CITY OF SAINT PAUL
Christopher B. Coleman, Mayor

DATE: February 19, 2015

TO: Planning Commission

SUBJECT: *West Side Flats Master Plan and Development Guidelines – Summary of Public Testimony and Committee Recommendations*

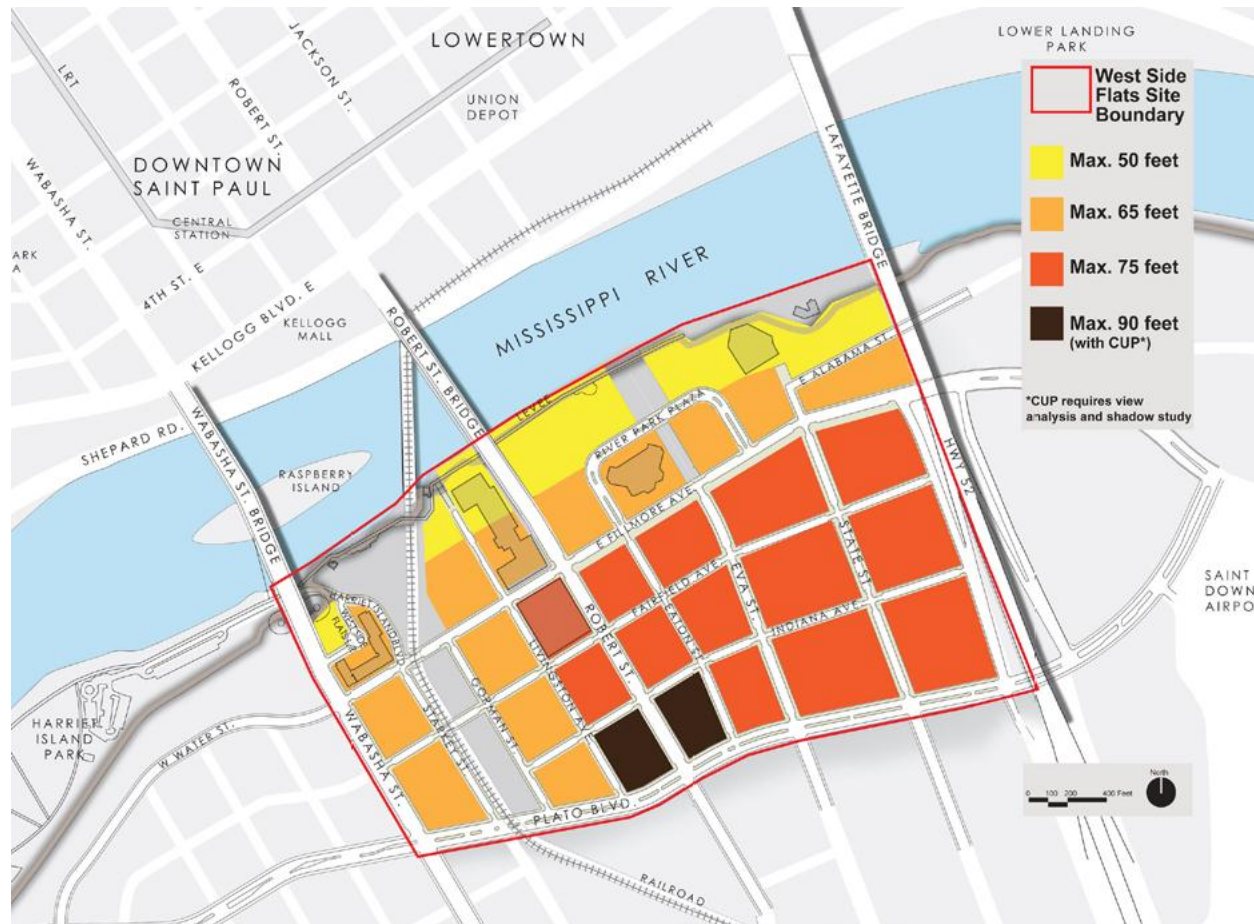
Most of the opposition to the draft Master Plan was presented by current or past employees of Rexam. They stated strong concern that the Rexam building is not shown on the Illustrative Plan on pg. 64, and that it is replaced with Eva Street Park and three new streets. Although the draft Master Plan states that the construction of new streets and parks throughout the planning area would be likely only in conjunction with private redevelopment; that parcels can be put to any legal use permitted under current zoning until such time as the City has the resources to build the recommended streets and parks; and that infrastructure changes in the area east of Robert and south of Fillmore are likely to occur in Phase IV (of IV, 20-30 years out), Rexam employees feel the future of their company is threatened. Most of the Rexam speakers asked that the Phase IV improvements be deleted from the Master Plan.

1. Remove the proposed streets and park east of Robert Street between Fillmore Avenue and Plato Boulevard from the Master Plan base map, which would remove them from all of the individual master plans (land use, urban design, acceptable building heights, street system, transit system, pedestrian and bike circulation, parks and open spaces, green infrastructure and public art) as well as the Illustrative Plan. The Illustrative Plan would show existing buildings and streets east of Robert between Fillmore and Plato, with a “bubble” explaining future strategies to pursue as redevelopment occurs in this area. As an example, a revised Street System Plan and Illustrative Plan are attached showing how the maps would look with these changes.
